Architectural Review Board Staff Report

Project Type: Site Development Section Plan

Description: **Peter Steffan, Proposed Lot 1 (AutoZone):** A Site Development Section Plan, Landscape Plan, Lighting Plan, Architectural Elevations, and Architect’s Statement of Design for a 0.88 acre tract of land zoned “PC” Planned Commercial District, located north of Chesterfield Airport Road west of its intersection with Arnage Boulevard.

Proposed Architectural Elevation—Front and Rear Elevations

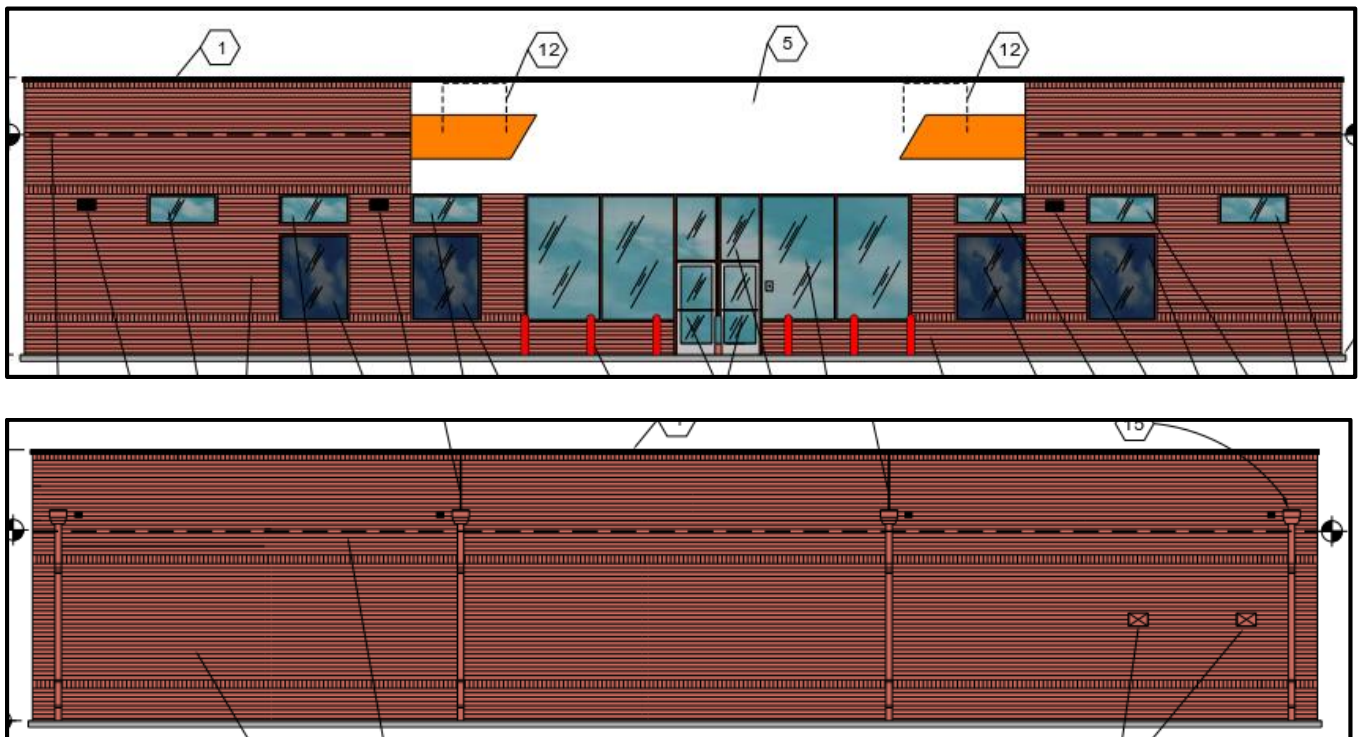
The building is rectangular shaped and lacks articulation; each of the four elevations is completely flat. The applicant has utilized brick soldier courses around the building to provide variation and interest. The front elevation is the only elevation that contains material variety with the provision of faux and clerestory windows in addition to the large glass storefront.

- *Provide entry recesses, plazas, roof overhangs, wall fins, projecting canopies or other similar features indicating the building's entry points while providing protection.*

SITE DEVELOPMENT SECTION PLAN

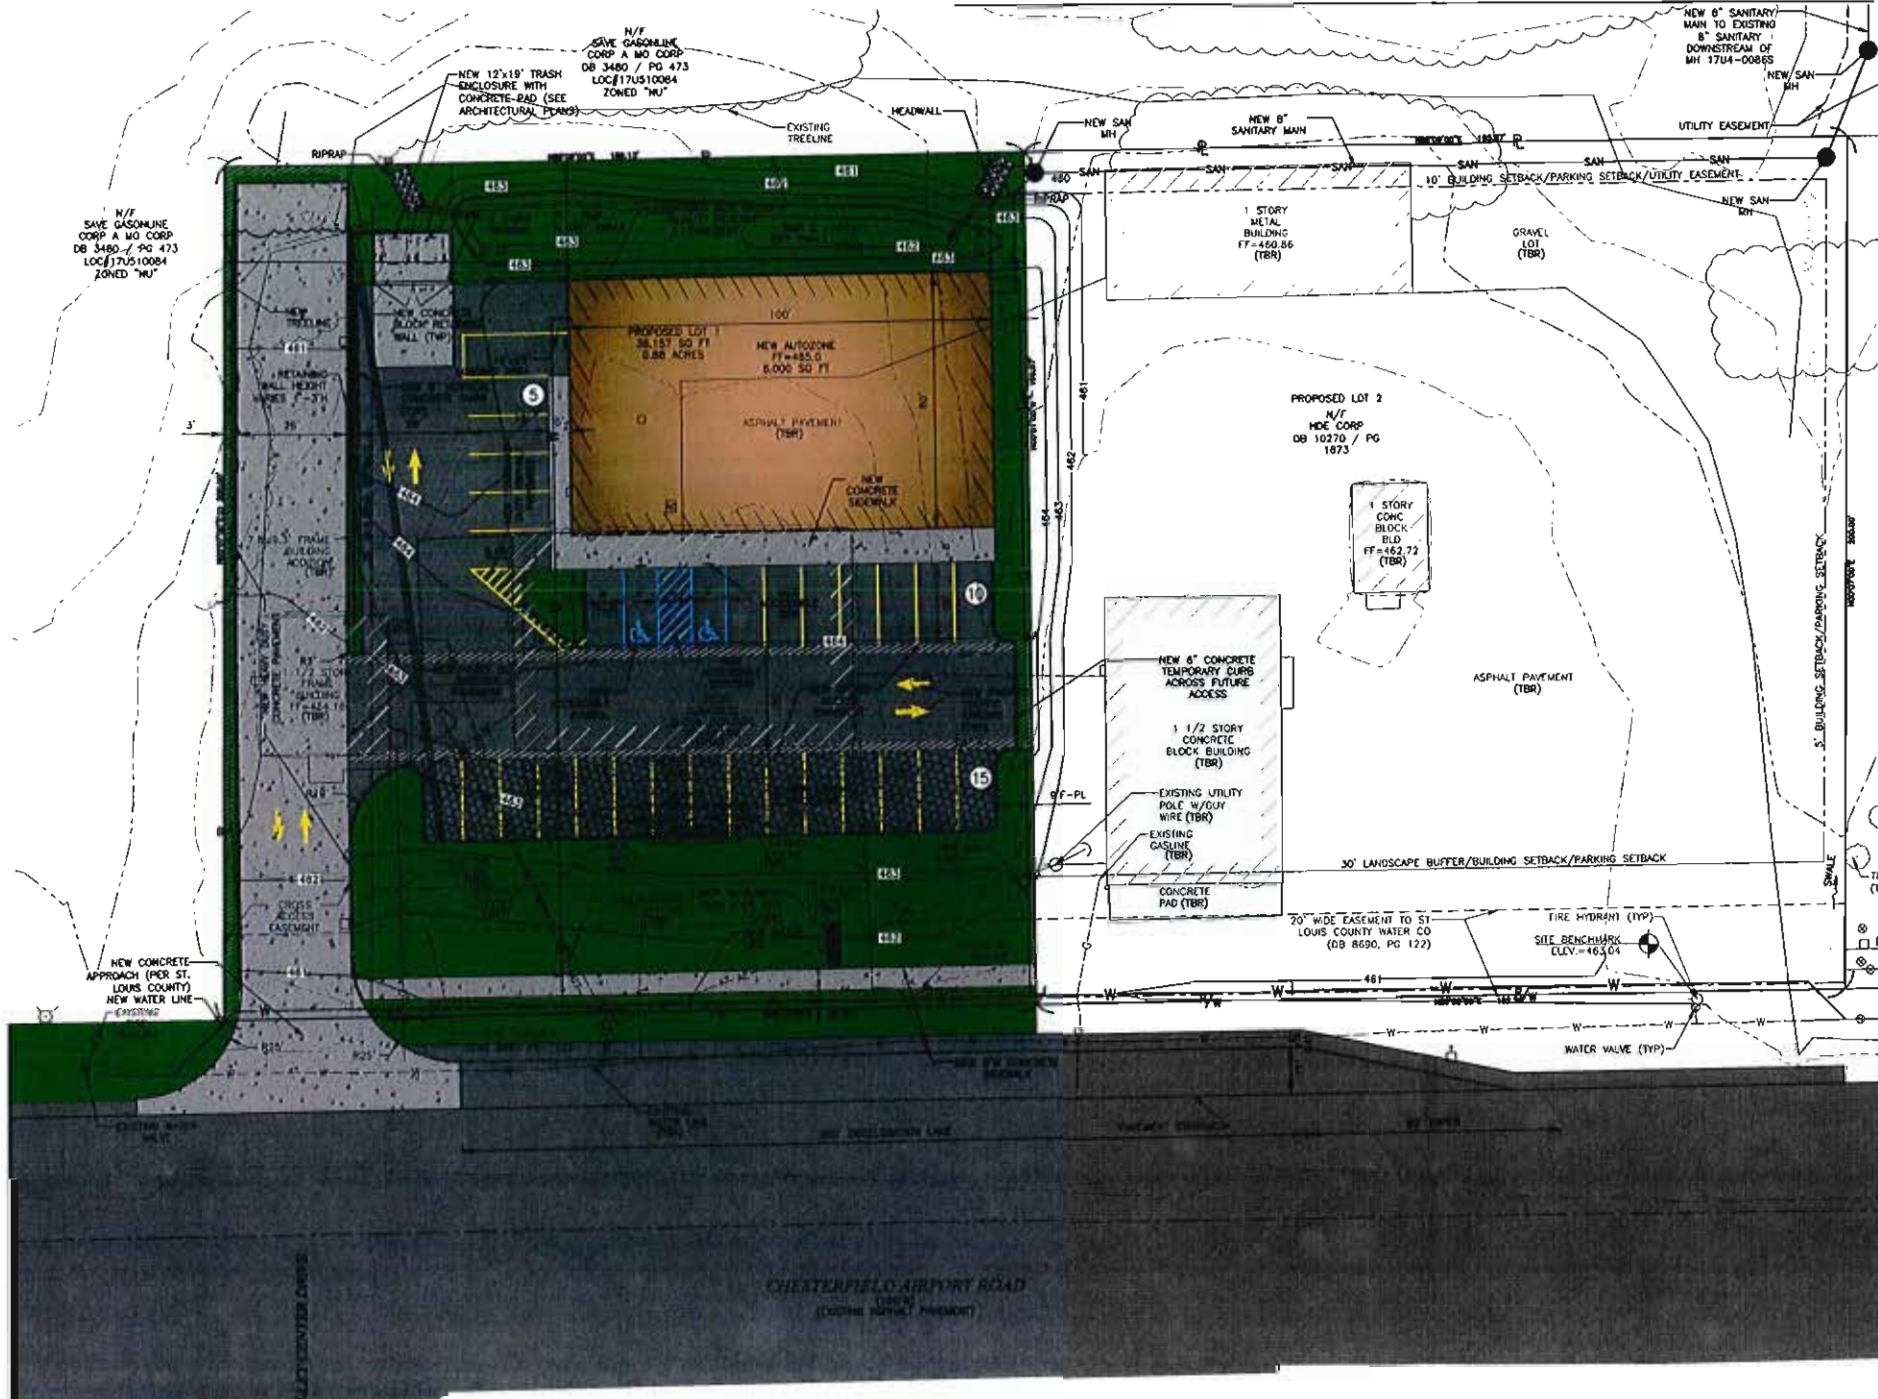
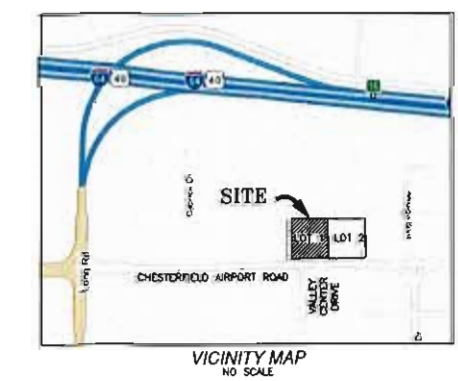
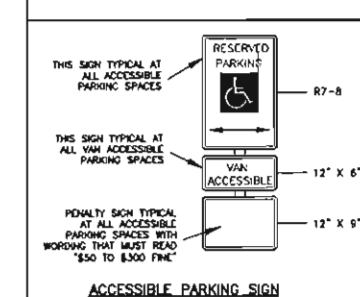
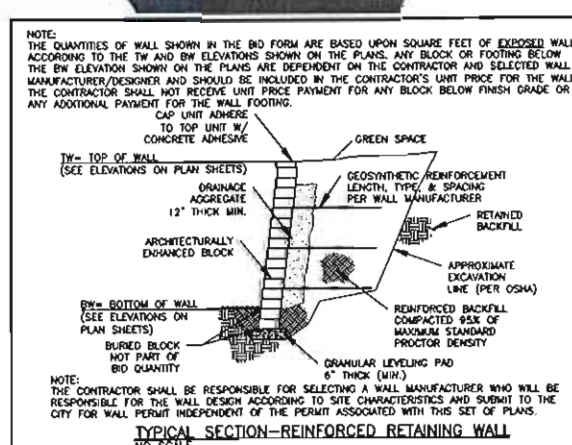
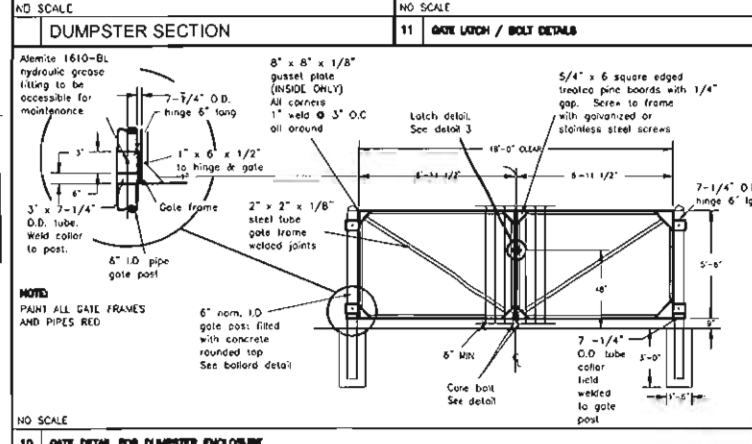
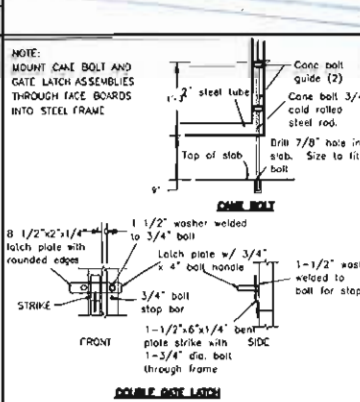
The dumpster enclosure detail provided on the Site Development Section Plan calls for smooth face block. However, the Architect's Statement of Design states that the dumpster enclosure will be constructed of the same material as the building. Staff will recommend that the detail be revised to reflect the brick and this item will be addressed prior to Planning Commission review.

- The proposed building utilizes similar materials on all elevations.
- The trash enclosure is currently shown as being constructed of smooth face block; however, as discussed earlier in the report, Staff recommends that the applicant utilize the same brick being utilized on the building in compliance with the Architectural Review Design Standards for the Chesterfield Valley.
